**RECALL
BULLETIN:**
80624

SUBJECT:
Install new
Manufacturer
Federal
Certification
Tag and
Occupant and
Cargo Carrying
Capacity Tag

ISSUE DATE:
July 2008

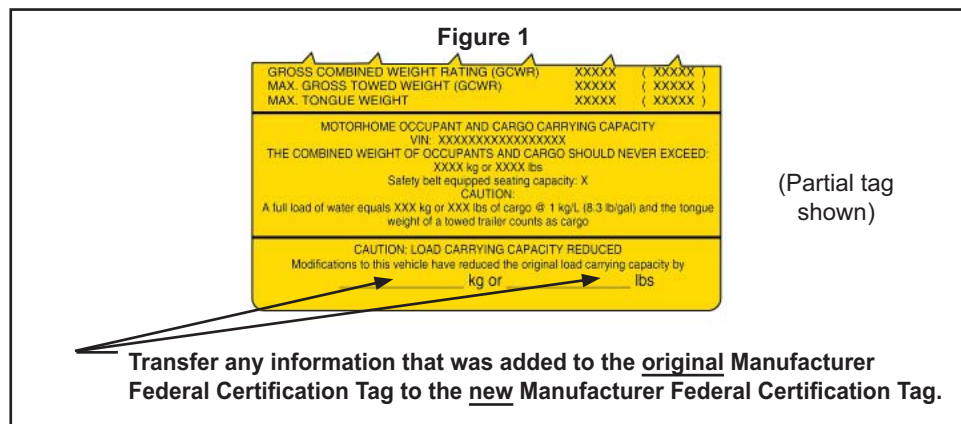
Fleetwood Enterprises, Inc., has discovered that motor homes manufactured May 19, 2008 through June 20, 2008 have an incorrect Occupant and Cargo Capacity Rating listed on the Manufacturer Federal Certification Tag and the Occupant and Cargo Carrying Capacity Tag.

Retail owners of affected motor homes and dealers holding affected motor homes in inventory will receive a package from Fleetwood containing a new and corrected, **serial number specific**, Manufacturer Federal Certification Tag and Occupant and Cargo Carrying Capacity Tag. Verify eligibility by referring to the affected motor home serial numbers listed at the end of this Bulletin before applying new labels.

1. Locate the original Federal Certification Tag, adhered to the wall behind the driver's seat (Class A coaches), or inside the driver's compartment (Class C coaches).
2. Record any additional weight information (if present) that was written on the original Manufacturer Federal Certification Tag due to the addition of options after the motor home was manufactured. (See Figure 1.) Transfer this information to the new Manufacturer Federal Certification Tag using a black, fine point, permanent marker.

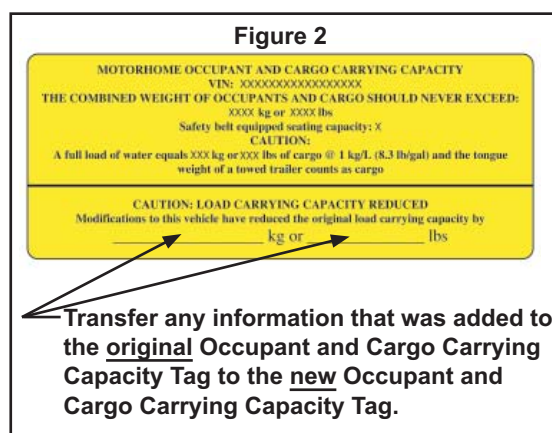
4. Locate the original Occupant and Cargo Carrying Capacity tag affixed to the inside of the entry door of the motor home. Record any additional weight information (if present) that was written on this tag due to the addition of options after the motor home was manufactured. (See Figure 2.) Transfer this information to the new Occupant and Cargo Carrying Capacity tag using a black, fine point, permanent marker. Then, remove and discard the original Occupant and Cargo Carrying Capacity tag.

5. Peel the adhesive backing from the new Occupant and Cargo Carrying Capacity Tag and carefully apply to the entry door in the same location as the original Tag. Use your fingers to smooth down newly-applied areas.
